# HOLDOVER

## **THE ROCK CHURCH SUBDIVISION**

APPLICATION NUMBER Holdover DATE January 19, 2006  
APPLICANT The Rock Church Subdivison  
REQUEST Subdivision

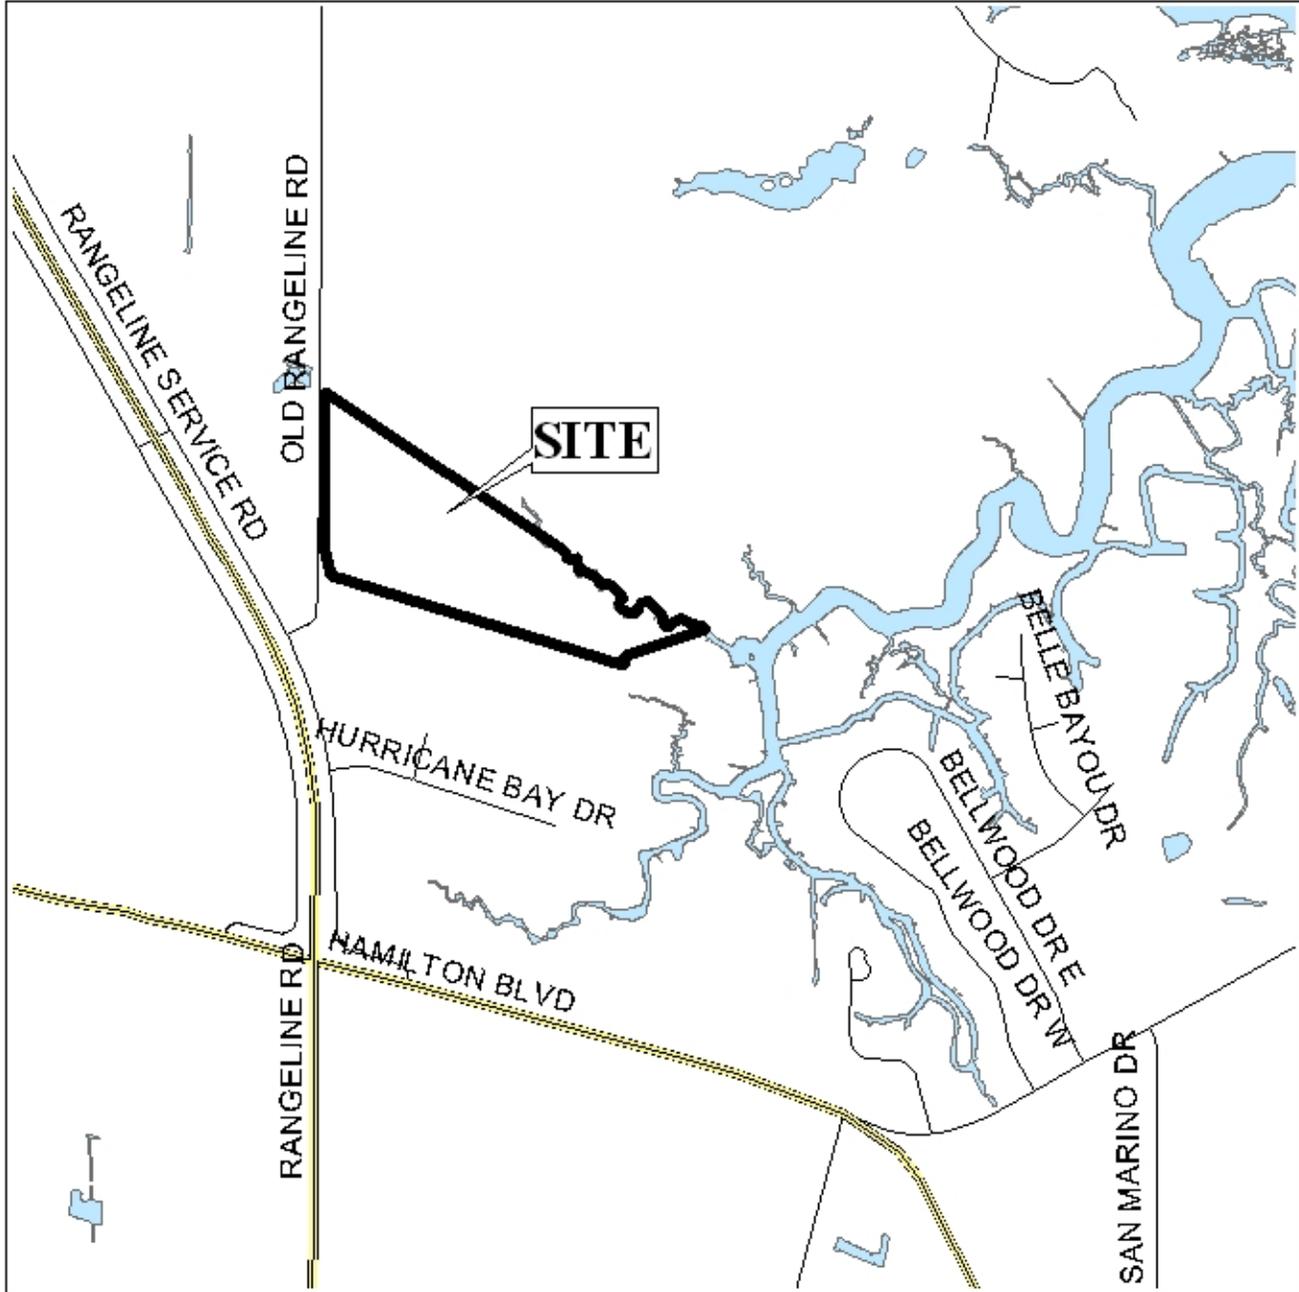
*This application was heldover from the January 5<sup>th</sup> meeting to allow the applicant time to submit a revised plat eliminating the flag-lot configuration. The applicant has provided the additional information.*

*The existing private road is constructed to a somewhat lesser standard than provided for in the Subdivision Regulations, but has been certified by the applicant's engineer to be in compliance with County private road standards. Therefore, a modification to VIII.E.2.c to allow the reduced standard would be appropriate. The plat as submitted indicates a 50' easement for the private road instead of the required right-of-way. The applicant's surveyor has agreed to modify the plat to comply with this requirement. The applicant's surveyor is also aware that all other requirements of VIII.E.2. will be applicable, and will be required prior to the recording of the final plat. Additionally, the placement of a note on the final plat stating that Lots 6 and 7 are denied direct access to Old Range Road should be required.*

*As the site is located in the 100/500-year floodplain, the area may be environmentally sensitive; therefore, the approval of all applicable federal, state and local agencies would be required prior to the issuance of any permits.*

*This site is located in the County, thus a note should be placed on the final plat stating that any lots which are developed commercially and adjoin residentially developed property must provide a buffer, in compliance with Section V.A.7. of the Subdivision Regulations.*

*With modification to VIII.E.2.c, the plat will meet the minimum requirements of the Subdivision Regulations and is recommended for Tentative Approval subject to the following conditions: 1) compliance with VIII.E.2., as modified by this approval (reduced construction standard) prior to the recording of the final plat; 2) the placement of a note on the final plat stating that Lots 6 and 7 are denied access to Old Rangeline and Rangeline Roads ; 3) the approval of all applicable federal, state and local agencies prior to the issuance of any permits; and 4) the placement of a note on the final plat stating that any property that is developed commercially and adjoins residentially developed property shall provide a buffer, in compliance with Section V.A.7. of the Subdivision Regulations.*
